Advisory Plan Commission
TECHNICAL REVIEW COMMITTEE

Project Name: Hawk’s Landing Primary Plat
Record Number: PCPP-25-3
TECH Meeting Date: September 18, 2025

TOWN OF BROWNSBURG STORMWATER/DRAINAGE PLAN REVIEW

NAME OF PROJECT: Hawk's Landing
DESIGN PACKAGE: Primary Plat
DESIGNER: Weihe Engineers

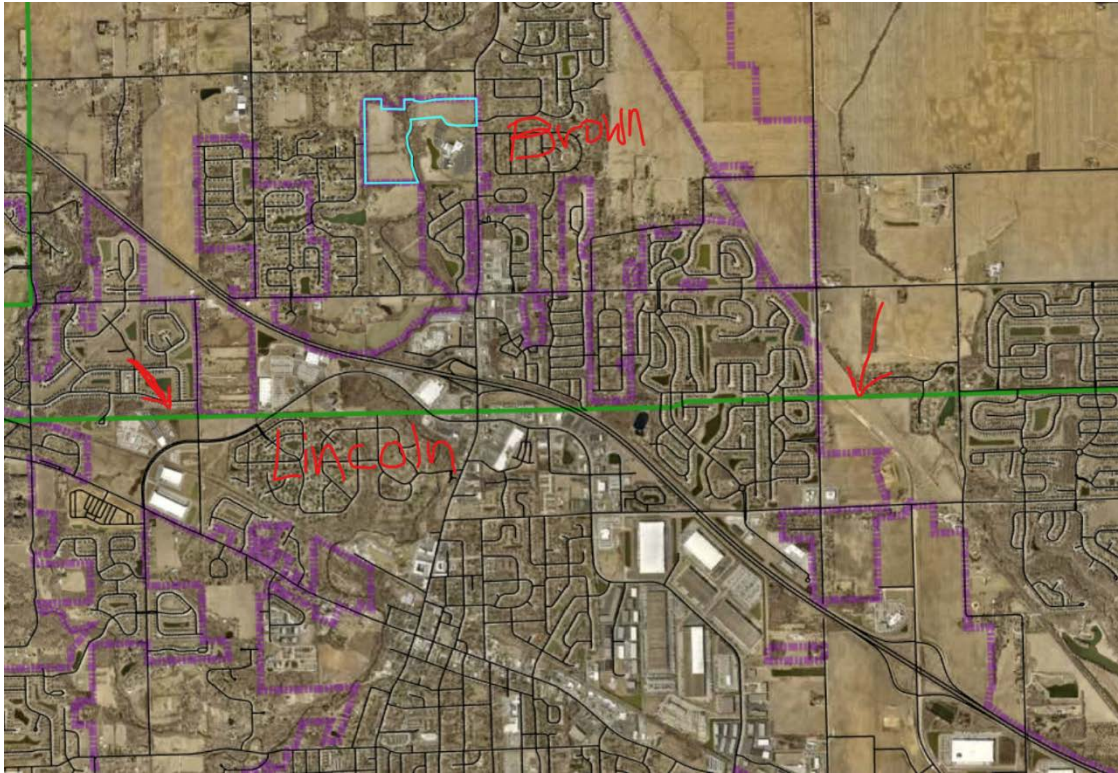
- b) Label what the proposed amenities are on the legend or plat.

- c) There need to be calculations for required and proposed vegetation on the landscape plan.
- d) The tree preservation area is currently just being shown with a pale green outline. Adding a cross hatch would make it easier to see.
- e) Add names to all new streets and write if the streets are public or private.
- f) Mark the size of existing water, storm water, and sanitary sewer systems.
